**1940 Rosenbaum Hse.
Florence,
AL**

ROSENBAUM HOUSE
FLORENCE, ALABAMA
PROJECT NO. 93093

OBSERVATION OF EXISTING STRUCTURE

AUGUST 21, 1993

FIG. 1

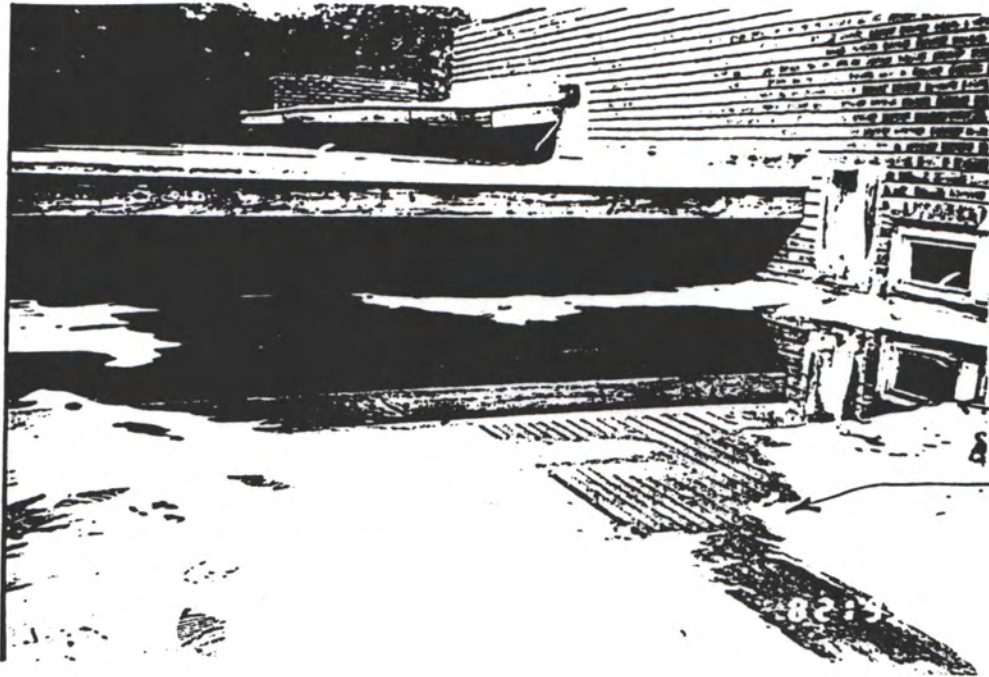
The roof framing appears to be sagging over the breakfast area (1948 addition). Water is ponding on the roof (Fig. 1) and there is evidence of water damage to the plywood ceiling in this area (Fig. 2). This problem was addressed in the 1968 repairs but evidently the solution has not been adequate.

FIG. 3

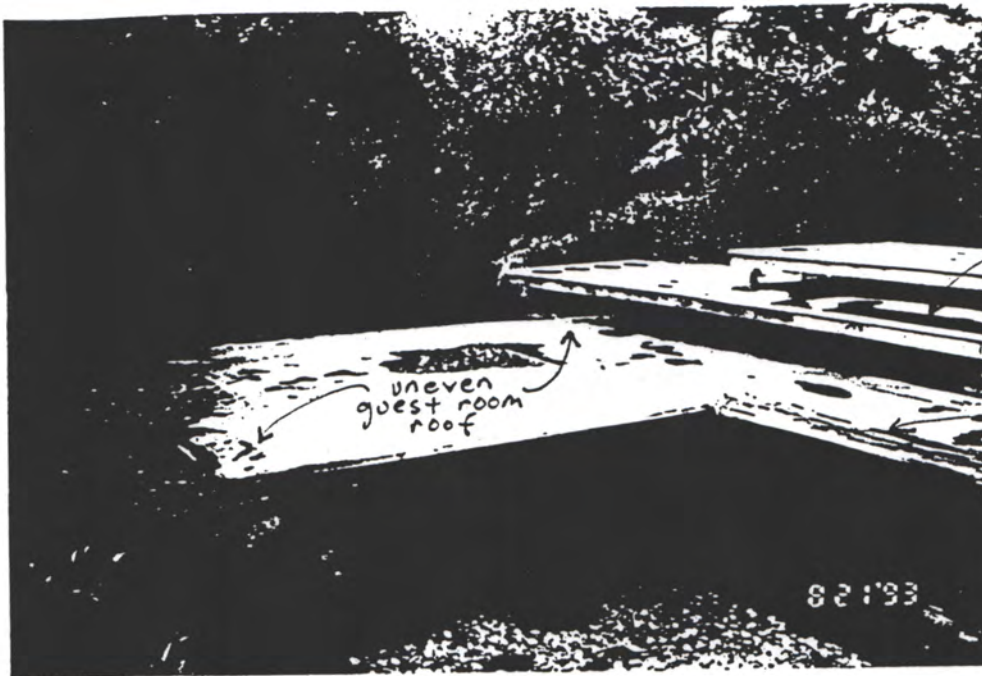
The entire roof over the guest bedroom ('48 addition) is extremely uneven and appears to be close to collapsing (Fig. 3). The extent of the damage can not be determined without removing the interior ceiling or roofing. There is also evidence of termite damage in this area.

FIG. 4.

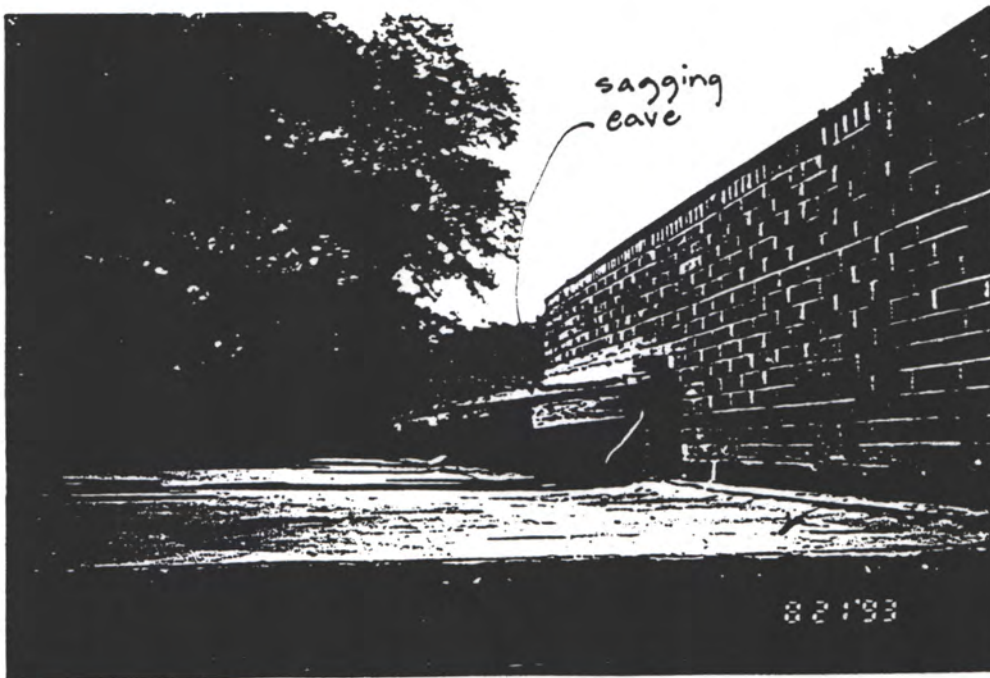
The cantilevered eaves are sagging at various locations around the house (Fig. 4, 5, & 6). The fascia board that was added in the 1968 renovation has become separated and warped at numerous locations (Fig. 7). It was originally attached with glue. The fascia at the east wall of the '48 addition at the courtyard is decayed badly and covered with plastic at this time.

FIG. 7A

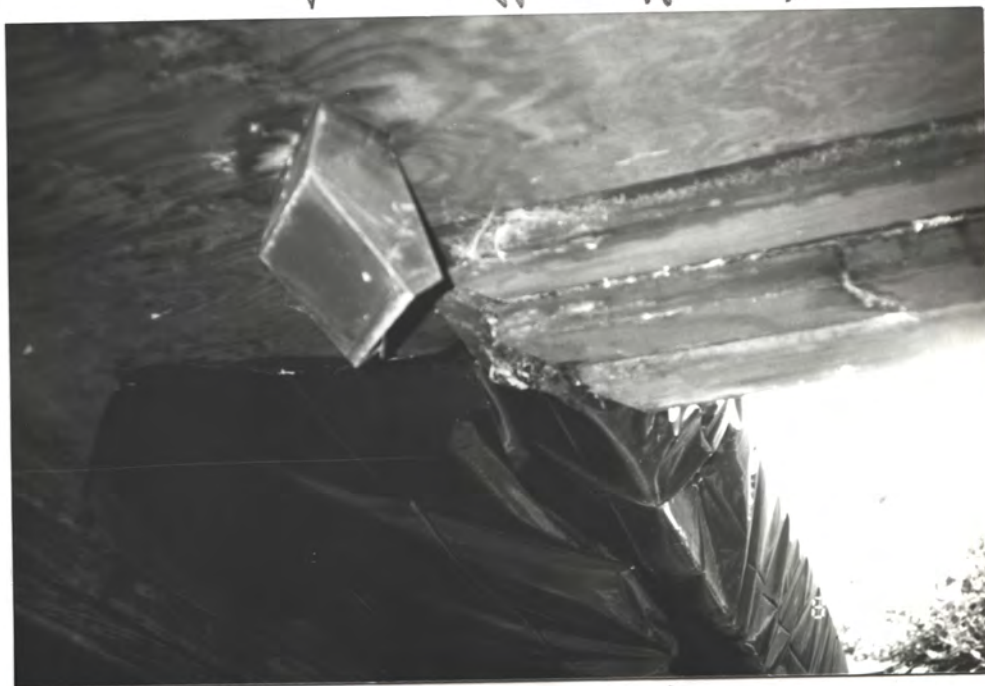
↳ polyethylene wrapped
over leaking roof edge
(promotes rot)
Weight removal.

Photos of roof rot & termite damage (by entry) Ron
Parrish
March 1995

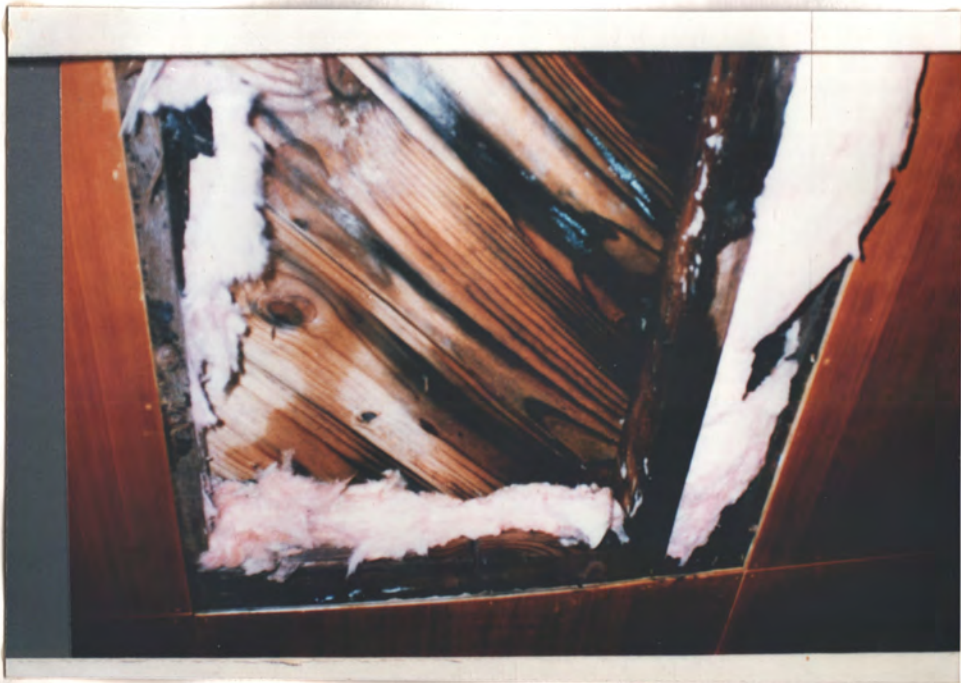
E. Hall, rot & termites
